Agenda Item: AH15, AH03

Source: Panasonic (Matsushita Communication Industrial Co., Ltd.)

Title: Text Proposal for Timing relation of PRACH and AICH  
(25.211 7)

Document for: Discussion & Decision

Fig.1 Timing of PRACH and AICH transmission in the case of 15 access slots within 2 frames as seen by the UE, with AICH transmission timing set to 0.

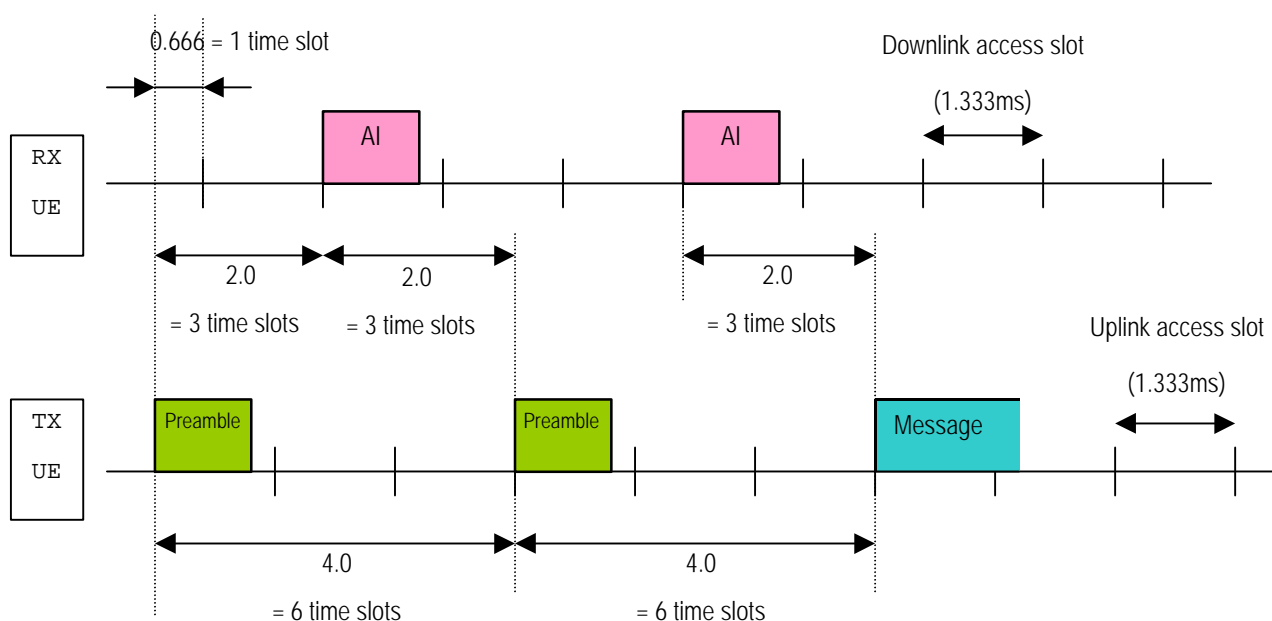
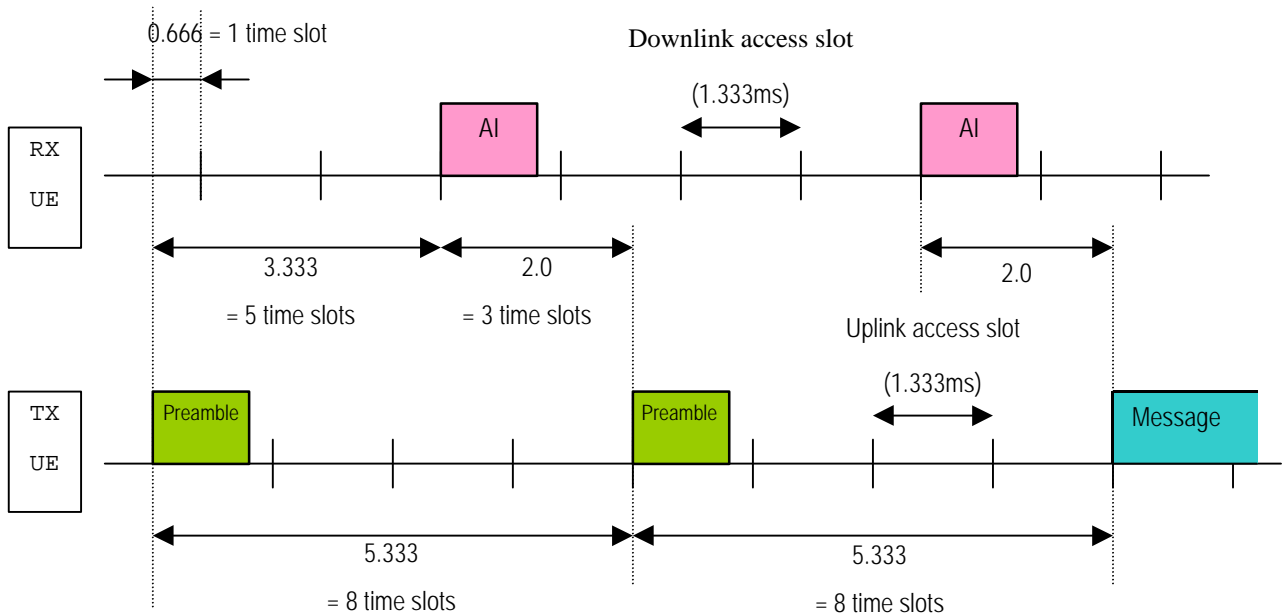
Currently the timing offset between PRACH and AICH ( $T_a$ ) has been defined to 0.5ms. From implementation point of view, the value of 0.5ms is not reasonable. Because it is not directly related to slot period and frame period. And there is no strong reason to persist in 0.5ms. On these reasons, this document proposes to change  $T_a$  to 1 slot duration ( $=0.666$ ms). And the other time parameters should also be modified to fit new access slot structure. At present there are two candidates of access slot structure which are 15 access slots within 2 frames and 7 access slots within 1 frame. Fig.1 and Fig.2 are shown the former as example. In the later, some of the time parameters will be extended for 1 time slot duration at frame boundary. But in the both candidates, all of time parameters( $T_a$ ,  $\tau_{p-p}$ ,  $\tau_{p-m}$ ,  $\tau_{p-a}$  and  $\tau_{a-p}$ ) could be defined as multiple of time slot.

**Figure 28: Timing of PRACH and AICH transmission as seen by the UE, with AICH transmission timing set to 0.**

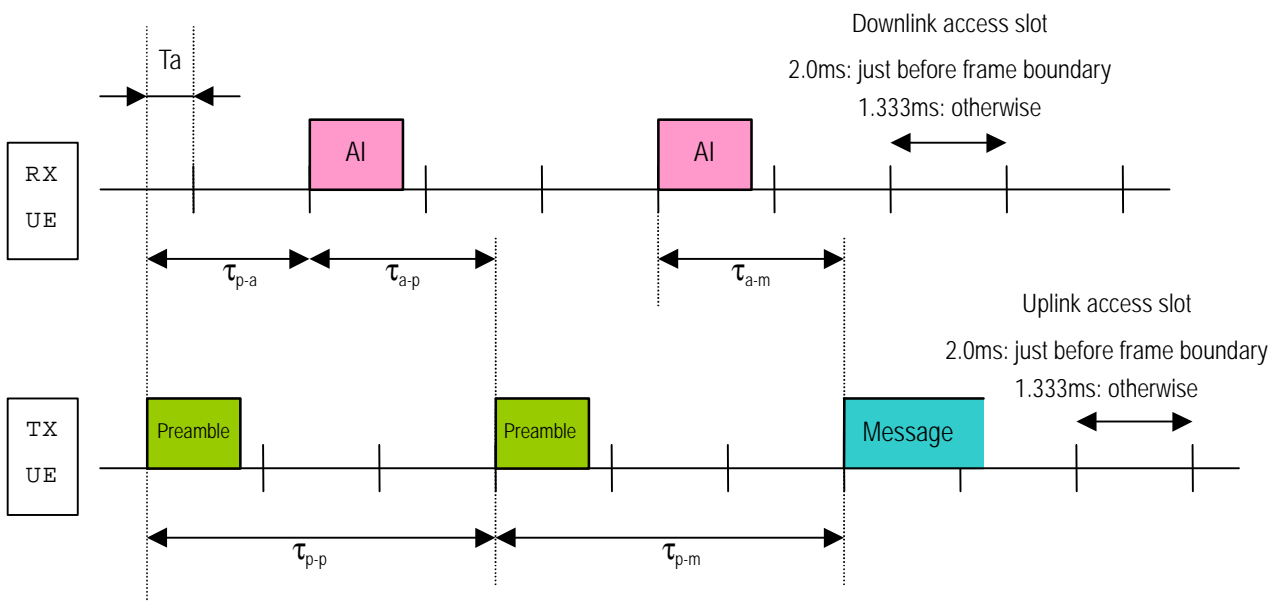
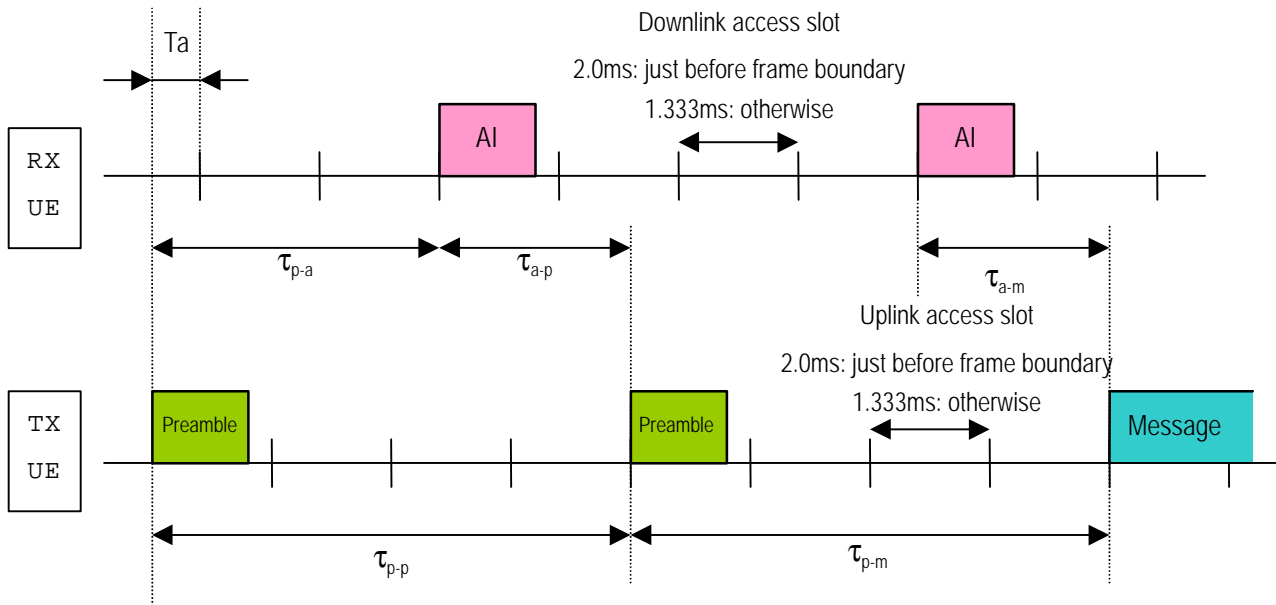
Figure 28 and Figure 29 illustrate the timing relation between PRACH and AICH as seen by the UE, with AICH transmission timing set to 0 and 1, respectively. The timing figures define the case where all access slots are available. If not all access slots are available, Figure 28 and Figure 29 define the minimum values for  $\tau_{p-p}$ ,  $\tau_{p-m}$ ,  $\tau_{p-a}$  and  $\tau_{a-p}$ .

- Both uplink and downlink access slots of length 2.0ms just before frame boundary and otherwise 1.333ms are defined.
- For each downlink access slot there is a corresponding uplink access slot.
- The preambles are to be transmitted time aligned with the uplink access slots.
- The downlink access slots are transmitted time aligned with the PCCPCH frame boundary.
- An uplink access slot is transmitted a specified time  $\tau_{p-a}$  before the corresponding downlink access slot.
- Subsequent preambles can be transmitted either three or four access slots after the latest transmitted preambles ( $\tau_{p-p}$  is either 3 or 4 access slots), depending on the AICH transmission timing value.
- The message can be transmitted either three or four access slots after the latest transmitted preamble ( $\tau_{p-m}$  is either 3 or 4 access slots), depending on the AICH transmission timing value.

The timing offset ( $T_a$ ) between uplink and downlink access slots, as seen by the UE, is same with 1 slot duration of 0.666ms.

The timing of preamble-to-AICH ( $\tau_{p-a}$ ) has ~~four~~ two alternative values: 2.666ms when there is frame boundary during  $\tau_{p-a}$  and otherwise 2.0ms, or 4ms when there is frame boundary during  $\tau_{p-a}$  and otherwise 3.333ms, depending on the AICH transmission timing value.

The timing of AICH-to-preamble ( $\tau_{a-p}$ ) has ~~two~~ one alternative values: 2.666ms when the corresponding preamble belongs to the next frame, and otherwise 2ms.

The timing of AICH-to-message ( $\tau_{a-m}$ ) has ~~two~~ one alternative values: 2.666ms when the corresponding message belongs to the next frame, and otherwise 2ms.
